# INNER WEST

## DEVELOPMENT ASSESSMENT REPORT

<b>Application No.</b>	DA/2020/0375
<b>Address</b>	115 Short Street BIRCHGROVE NSW 2041
<b>Proposal</b>	Demolition of existing dwelling and construction of a new multi level dwelling with parking at rear and associated works
<b>Date of Lodgement</b>	21 May 2020
<b>Applicant</b>	Whiting Architects
<b>Owner</b>	Ms Belinda J Ainsworth
<b>Number of Submissions</b>	Seven (7) submissions with six (6) being unique
<b>Value of works</b>	\$1,300,000.00
<b>Reason for determination at Planning Panel</b>	Clause 4.6 variations exceed 10%
<b>Main Issues</b>	<ul style="list-style-type: none"> <li>• Adverse streetscape / heritage impacts</li> <li>• Unsatisfactory response to desired future character controls</li> <li>• Unsatisfactory on-site amenity outcomes</li> <li>• Adverse amenity impacts on adjoining properties;</li> <li>• Inadequate tree planting;</li> <li>• Variation to FSR, Site Coverage and Landscaping;</li> <li>• Site suitability</li> </ul>

<b>Recommendation</b>	Refusal
<b>Attachment A</b>	Plans of proposed development
<b>Attachment B</b>	Without Prejudice Conditions of Consent (if approved)
<b>Attachment C</b>	Clause 4.6 Exception to Deve

DRAWING	PROPOSED SITE PLAN/SITE ANALYSIS	CLIENT	LINDY ANSNORTH
ADDRESS	115 SHORT STREET		BIRCHGROVE, NSW 2041
SCALE	1:200 @ A3	DA APPLICATION	
DRAWN	JS	TRACED BY	BIRCHGROVE
CHECKED	SW	PROJ. NO.	A100
DATE	05.06.2020	REV	-

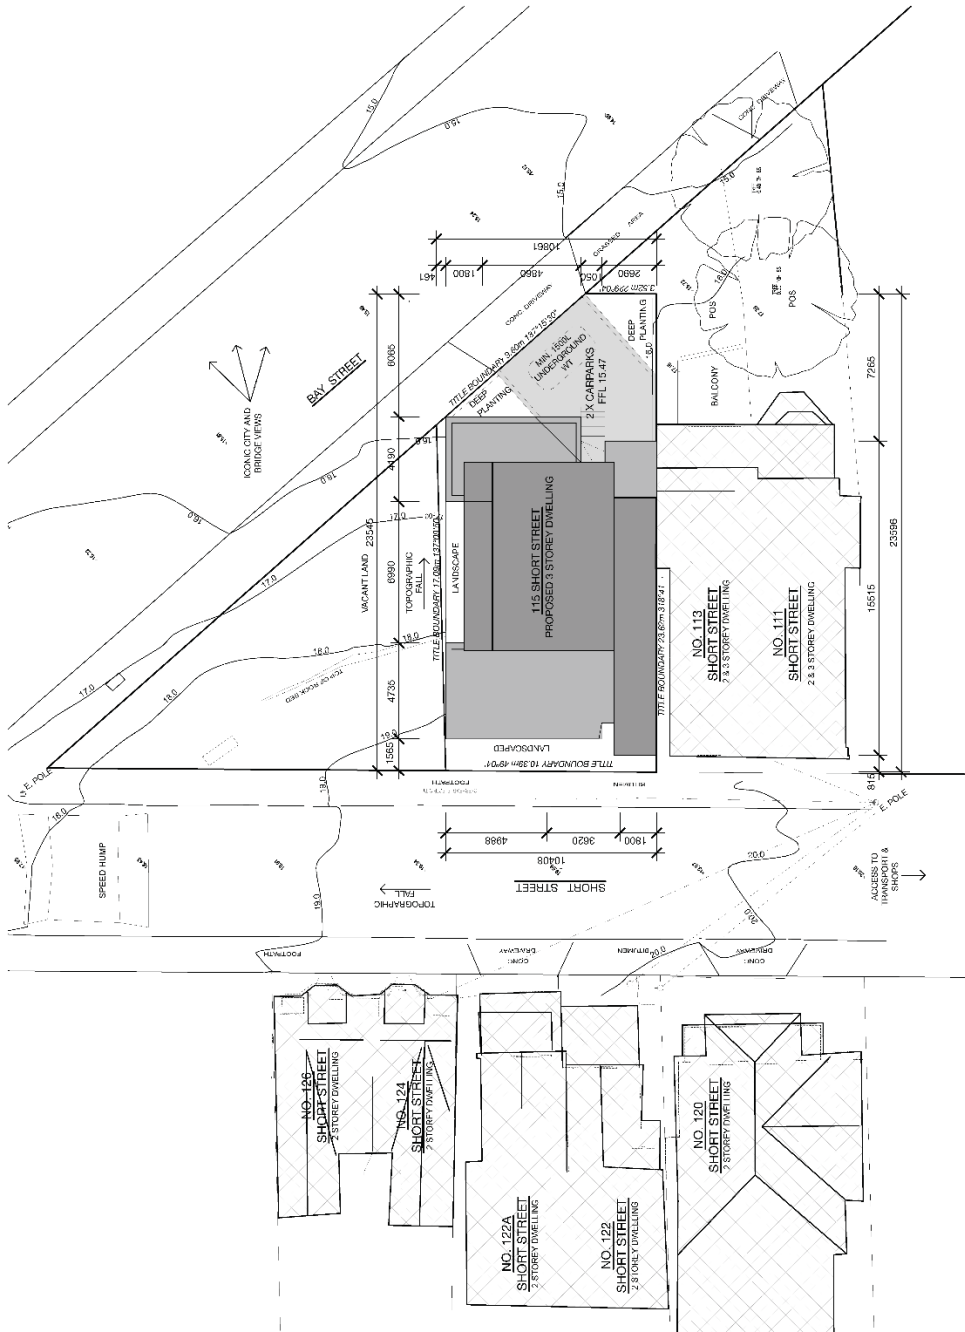
As such, significant portions of the triangular (planter box) landscaped areas cannot be included in landscaped area calculations where they have a dimension of less than 1m and/or are raised above 500mm from ground level (existing).

*"A review of the submitted Landscape Concept Plan, prepared by Whiting Architects, dated 5/05/2020, page No. A105 has found that there is insufficient planting space provided for a 400L replenishment tree in accordance with PREDA referral comments. The landscape concept is not supported in its current format.*

*It is requested that the landscape plans are amended to provide sufficient above and below ground space for an advanced stock 400L replenishment tree. It must be demonstrated that there is sufficient soil volume provided to sustain the specimen in the landscape upon maturity."*

1 PROPOSED WEST/STREETSCAPE ELEVATION  
A202 SCALE 1:100 @ A3

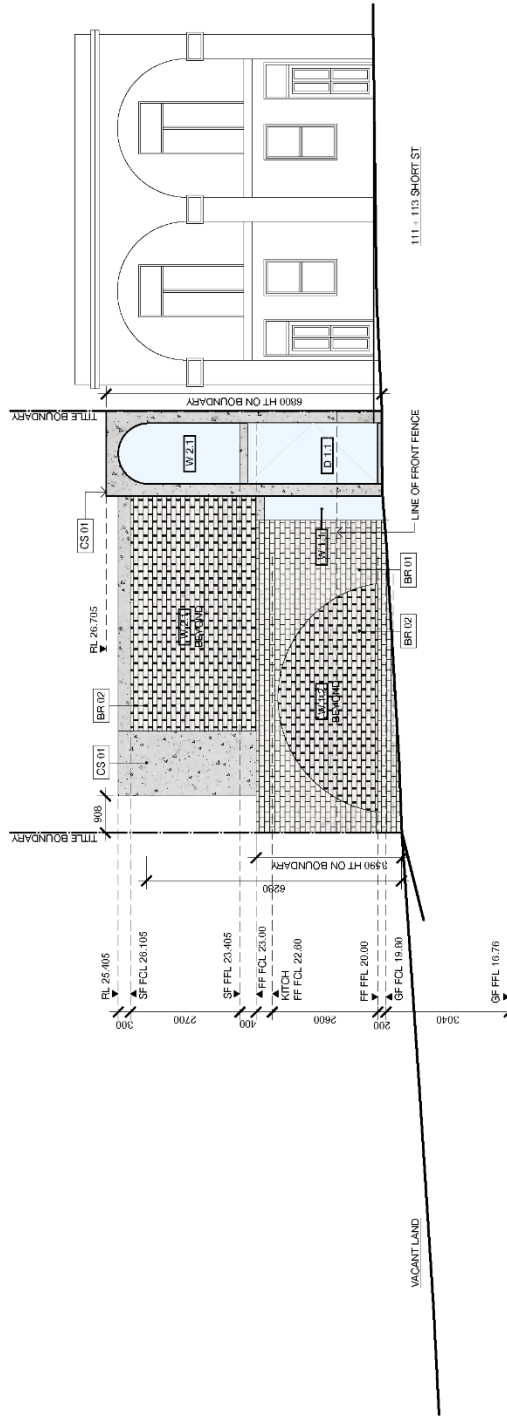
**Comment:** *The width of the west (streetscape) elevation will present to the street with horizontal detailing, rather than vertical. The width and the detail of the front façade must be amended to respect the characteristic width of dwellings and terraces in the Short Street streetscape.*

1 PRELIMINARY SECTION  
A300/ SCALE 1:100 @ A3

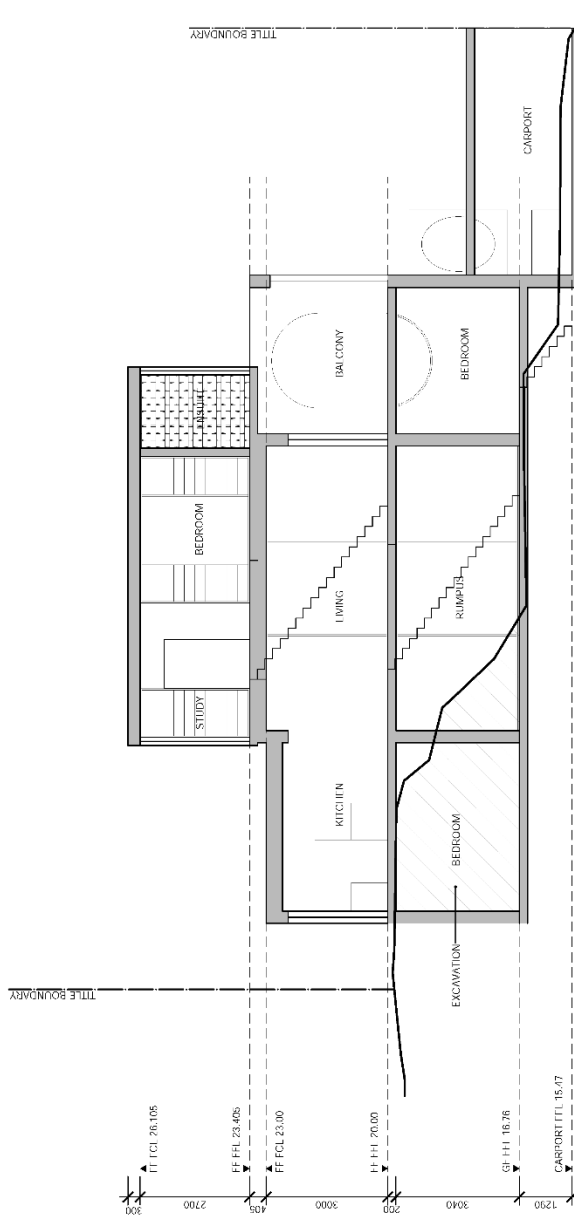
**Comment:** *The section drawing illustrates a large amount of excavation of sandstone is proposed to enable bedroom 3, approximately one third of the area of the rumpus room, the bathroom and basement storage on the ground level. Bedroom 3, the basement storage and one third of the northern section of the floor area of the rumpus room must be deleted from the ground floor level to retain the sandstone, to ensure the proposal is consistent with C1 a. and b. of Section C1.19 of the DCP.*
